**Elm Park ELC Design Review Response 24.11.04 FINAL.pdf**  
12290K

**10th and Greenwood Exhibit.pdf**

**CITY OF FLORENCE**  
**9TH STREET IMPROVEMENT PHASE 1**  
**GENERAL CONSTRUCTION -**  
**SHEET 5 OF 5**

**PLAN VIEW**  
1" = 20'

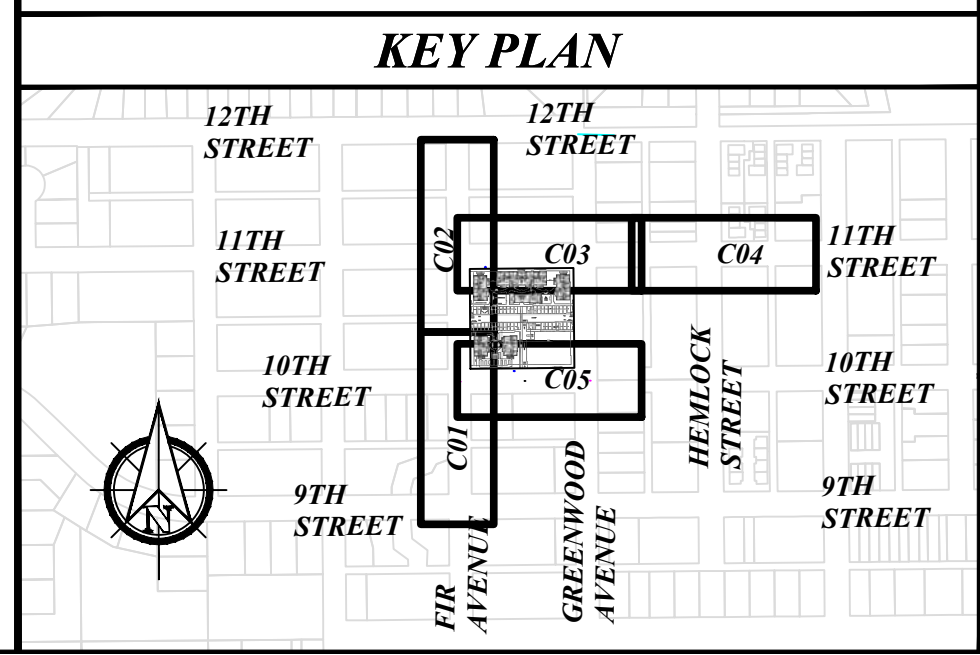
"We need 8 parallel parking spaces (four on Greenwood south of the alley; and four on 10th east of the drop-off lane.

The curb design shown at the corner of Greenwood and 10th eliminates two of our eight parking spaces.

Can that curb design be reviewed so we keep our 8 parking spaces?"

Working through the design, our engineers are looking at creating curb extensions (bulb outs) on the west side of Greenwood at 10<sup>th</sup> in order to get the sidewalk away from the property line and provide the four stalls on Greenwood and

10<sup>th</sup> Street. The bulb outs/curb extension also help with getting the crosswalk out of the existing medians.

Also in regards to the comment of the 66 foot right-of-way, the 50% level plans were not labeled correctly. They were drawn at 66 feet, but were simply labeled as 60 feet.
